Office Action Summary

10/580,344

OTT, JOSEF

DETAILED ACTION

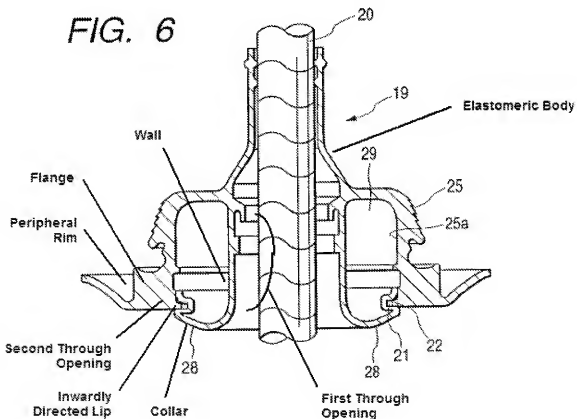
With regard to claims 1 and 3, as best understood by the examiner, Yamada et al. disclose the claimed seal in Figs. 4-6. See Figure below for a detailed explanation.

With regard to claim 7, the first opening actually begins at the curvature of the wall, proximate numeral 28. In that sense, the first opening can be considered to be above the second opening. In any case, the direction "above" is never positively defined in the claim with reference to any other part of the structure. Therefore, the first opening can be considered above or below the second opening.

With regard to claim 10, Yamada et al. disclose a face seal ring (i.e. the lip on the wall--see Figure above).

Examiner respectfully traverses. As can be seen in the Figure provided above, the first opening is at the front side of the seal, since the first opening starts at the curvature of the wall portion proximate numeral 28. The collar is also close to the first opening, as shown in the Figure. In any case, the terms "at" and "close to" are fairly broad. For example, the term "close to" certainly does not require the collar to be directly adjacent the first opening.
